## ADDENDUM NO. 03

**Project No.**24076

**Project Name:** TFSD Lincoln HVAC Replacement

**Date Issued:** April 15, 2025

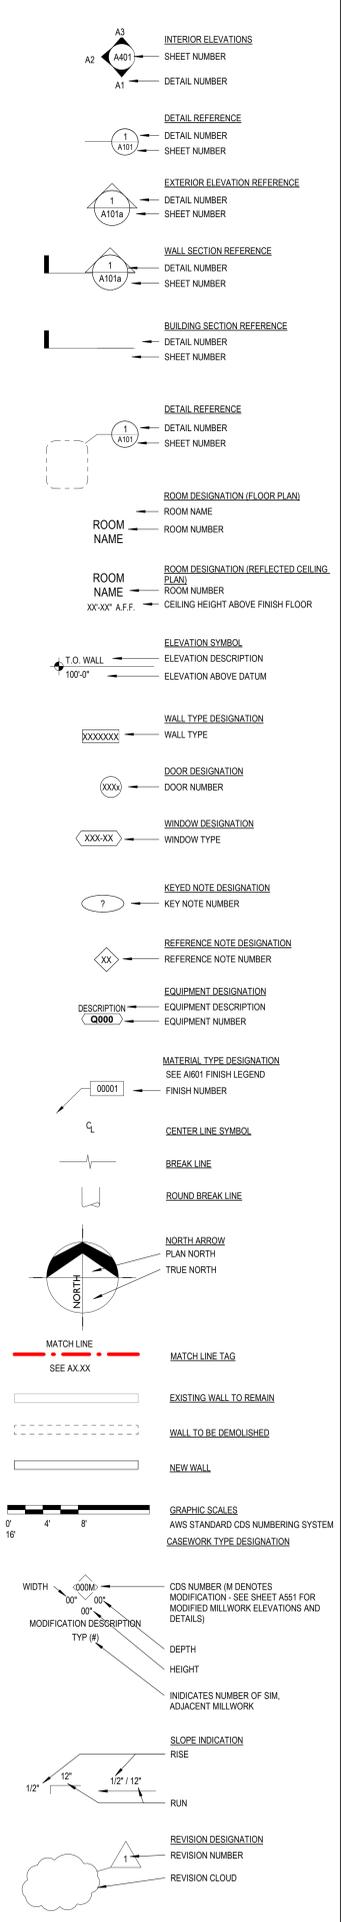
- **Response to RFI Question #6 Glazing - Tim Pollard**

Also, where the panels are going to be switched out with new panels, the existing panels are 1/4" thick and the replacement panels will be 1" thick. The existing panels are not held in with stops, perhaps they are glued in? What will be the required method to hold the new panels in place, aftermarket screw-applied stops or just glued in?

Provide a spandrel infill panel similar to existing. GlazeGuard 250WR – 1/4 " thickness composite aluminum prefinished panel with a high density Polypropylene core or an approved equal.

Project No: 24076, Drawn By: NB, Checked By: PR, Date: 02/27/2025, Sheet No: G0.02

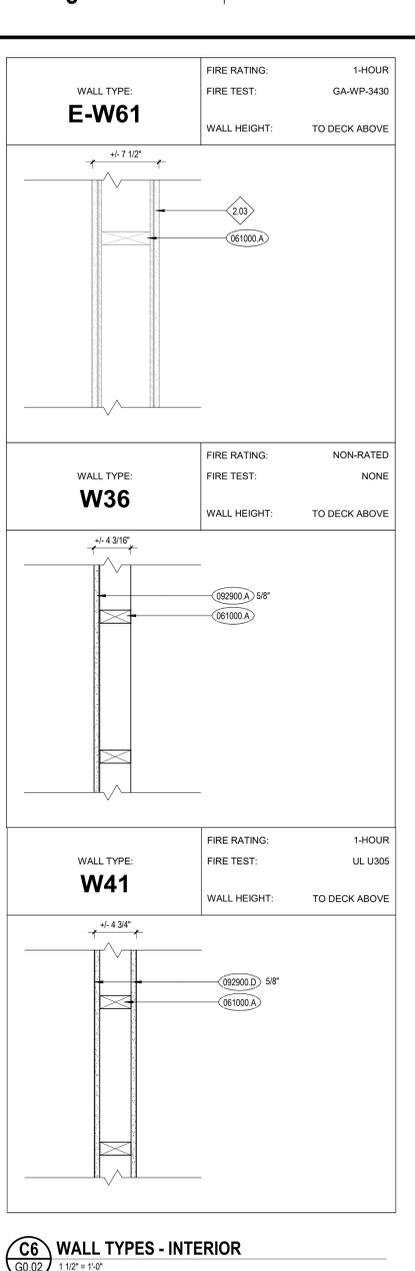
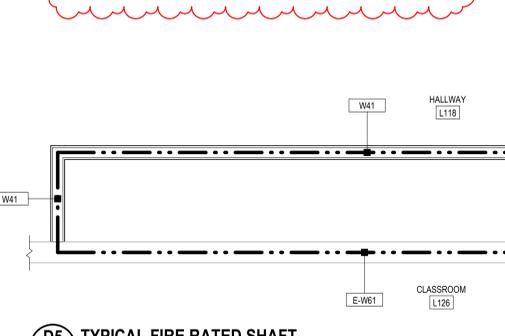
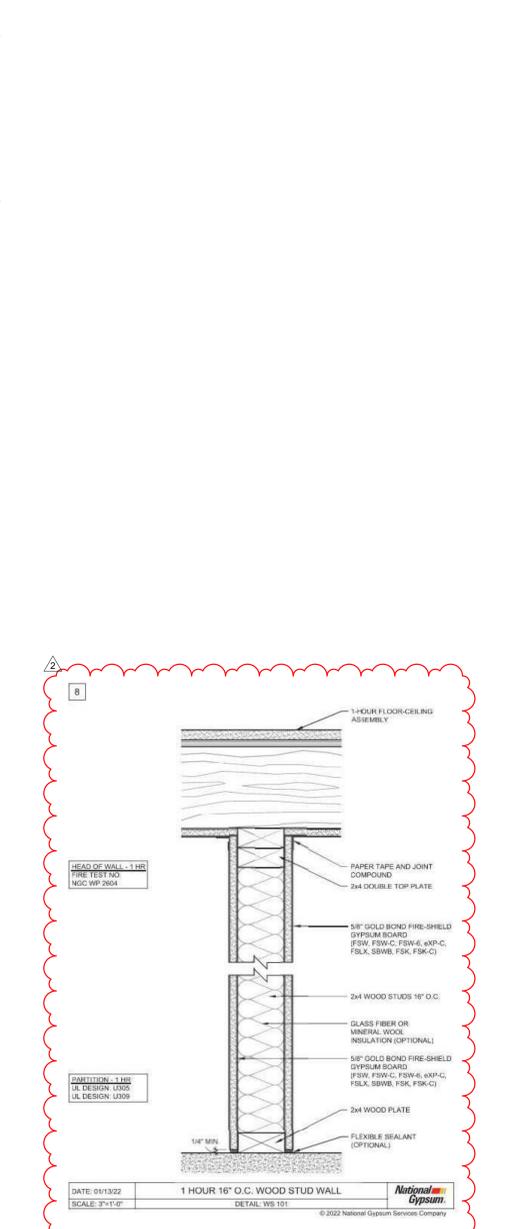
##### **G0.02: DRAWING INFORMATION.**

1. CONSTRUCTION TYPE ADDED.
2. NATIONAL GYPSUM UL-U305 – 1 HOUR WOOD STUD WALL DETAIL ADDED.
